## **DAMRICH SUBDIVISION**

Engineering Comments: The following comments should be addressed prior to acceptance and signature by the City Engineer:

APPLICATION NUMBER 4 DATE April 7, 2014

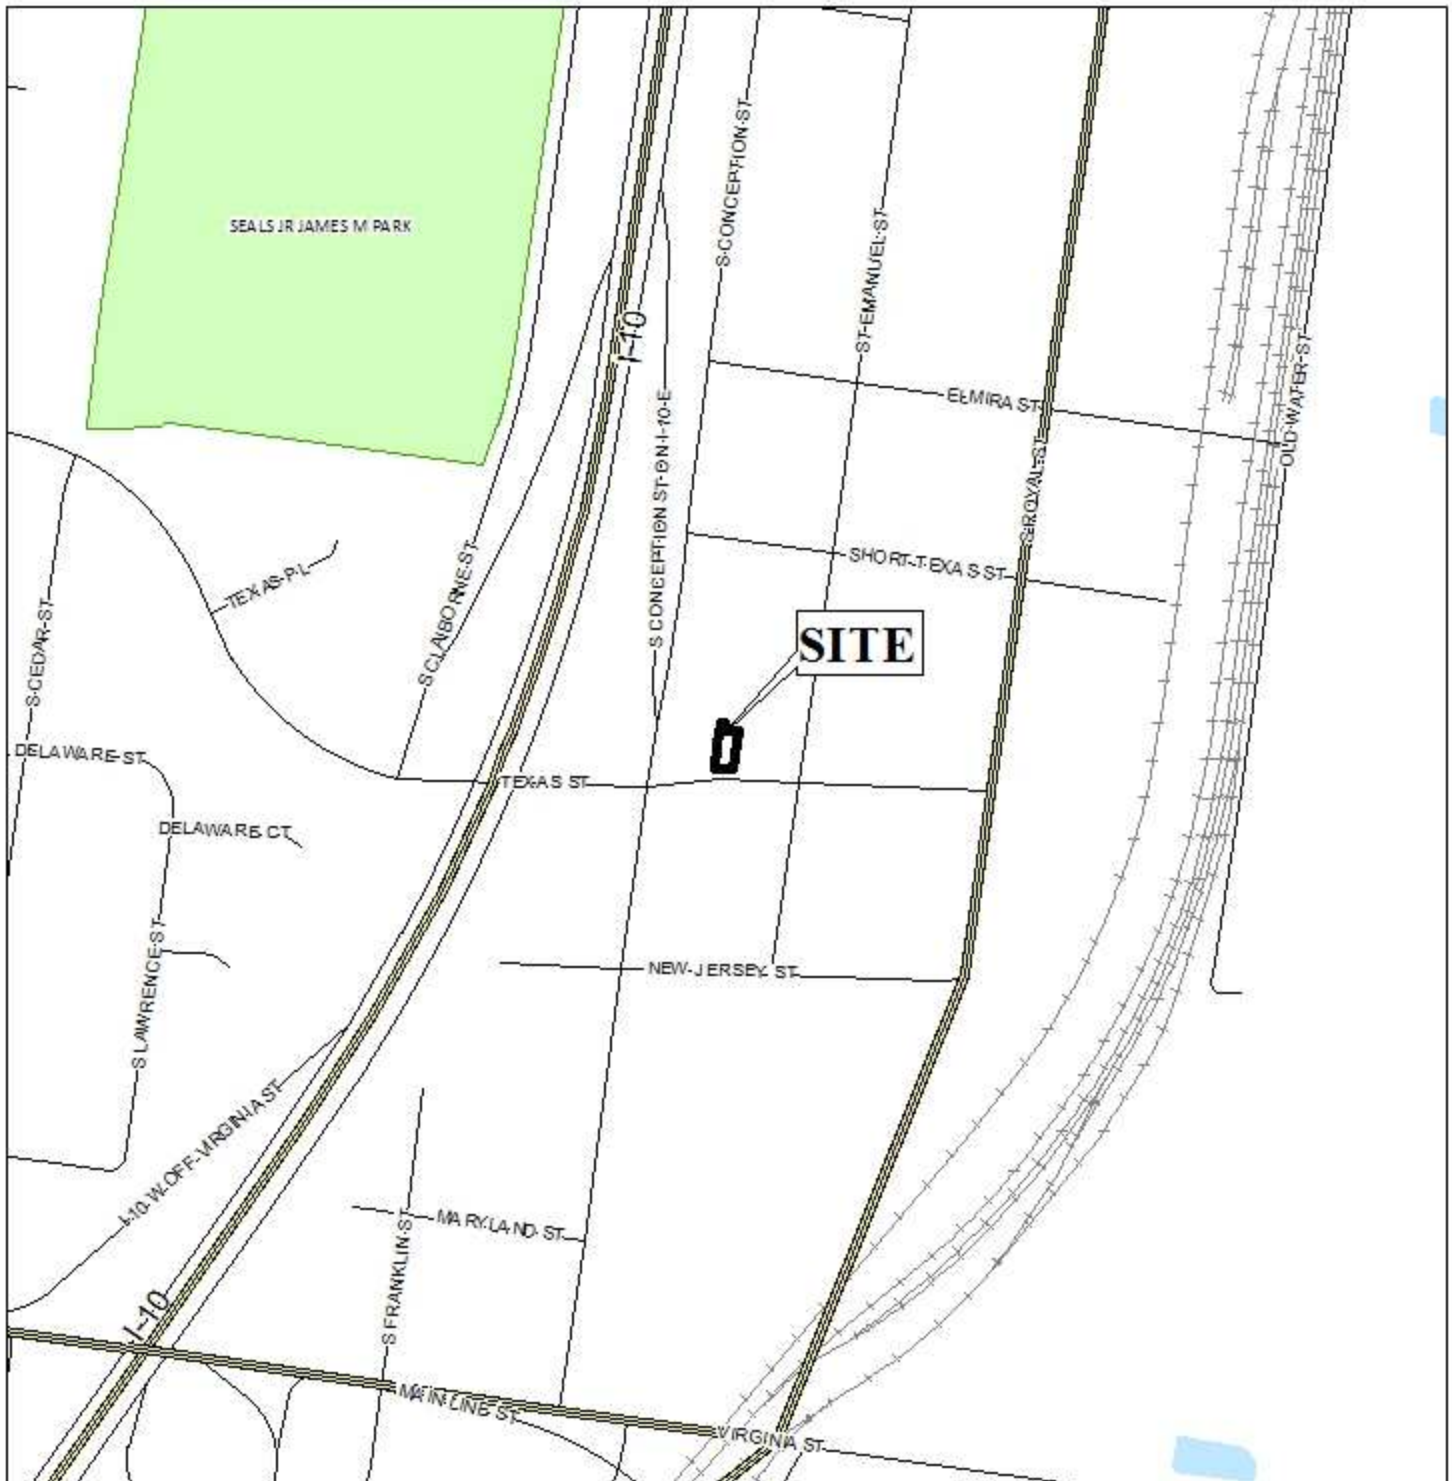
Due to the limited width of the proposed lot, 40  $\pm$  feet, access management is a concern. The site should be limited to one curb-cut, with the size, design and location to be approved by Traffic Engineering and conform to AASHTO standards. Access to the unimproved alley should be denied.

Due to the substandard width of the proposed lot (40  $\pm$  feet), and the substandard size in terms of area (3,400  $\pm$  square feet), a waiver of Section V.D.2. of the Subdivision Regulations would be required to approve the requested subdivision.

The 25-foot minimum building setback line, required in Section V.D.9., is not shown for the subdivision, but would be required on the final plat, if approved.

The preliminary plat does not include the size of the proposed lot in square feet or acres. The final plat should include this information.

It appears that the site may be located in AE and X-shaded flood zones associated with the Mobile River and Mobile Bay. The potential presence of floodplains indicate that the area may be environmentally sensitive; therefore, the approval of all applicable federal, state and local agencies would be required prior to the issuance of any permits or land disturbance activities.

- 1) placement of a note on the final plat stating that the lot is denied access to the adjacent unimproved alley;
- 2) placement of a note on the final plat stating that the lot is limited to one (1) curb-cut, with the size, design and location of the curb-cut to be approved by Traffic Engineering and conform to AASHTO standards.
- 3) depiction of the 25-foot minimum building setback line, as required by Section V.D.9. of the Subdivision Regulations;

- 4) the labeling of the lot with its size in square feet, or placement of a table on the plat with the same information;
- 5) compliance with Engineering comments (*The following comments should be addressed prior to acceptance and signature by the City Engineer: A. Provide all of the required information on the SUBDIVISION PLAT (i.e. signature blocks, signatures, certification statements, written legal description, required notes, legend, scale, bearings and distances). B. Add a note to the SUBDIVISION PLAT stating that a Land Disturbance permit will be required for any land disturbing activity in accordance with the of the Storm Water Management and Flood Control Ordinance (Mobile City Code, Chapter 17, Ordinance #65-007 & #65-045), latest edition. Storm water detention may be required for any future addition(s) and/or land disturbing activity. Also, as shown on the 1984 aerial photo, this lot will receive historical credit of impervious area towards storm water detention requirements. Coordinate with City Engineering Department staff to establish the exact amount prior to the submittal of the Land Disturbance Permit application. C. Add a note to the Plat stating that the approval of all applicable federal, state, and local agencies (including all storm water runoff, wetland and floodplain requirements) will be required prior to the issuance of a Land Disturbance permit. D. Revision of the plat to label each lot with its size in acres and square feet, or the furnishing of a table on the Plat providing the same information; E. Provide a written legal description for the proposed subdivision and matching bearing and distance labels. F. Show and label all flood zones. G. Show and label the MFFE (Minimum Finished Floor Elevation) on each lot that contains an AE, V, or X (shaded) flood zone designation. H. Show and label each and every Right-Of-Way and easement. I. Provide and label the monument set or found at each subdivision corner. J. Add a signature block for the Owner, Notary Public, Planning Commission, Traffic Engineer, and City Engineer. K. Provide the Surveyor's Certificate and Signature. L. Provide the Owner's (notarized), Planning Commission, and Traffic Engineering signatures. M. Add a note that sidewalk is required to be constructed along the frontage of each lot, or parcel, at time of development, unless a sidewalk waiver is approved. N. Do not provide a County Engineer's signature block on the Plat. The County Engineer no longer signs plats within the municipal limits of the City of Mobile. O. Clarify the actual Subdivision boundary on the Plat; indicating any existing parcels adjacent to Lot 1.)*)
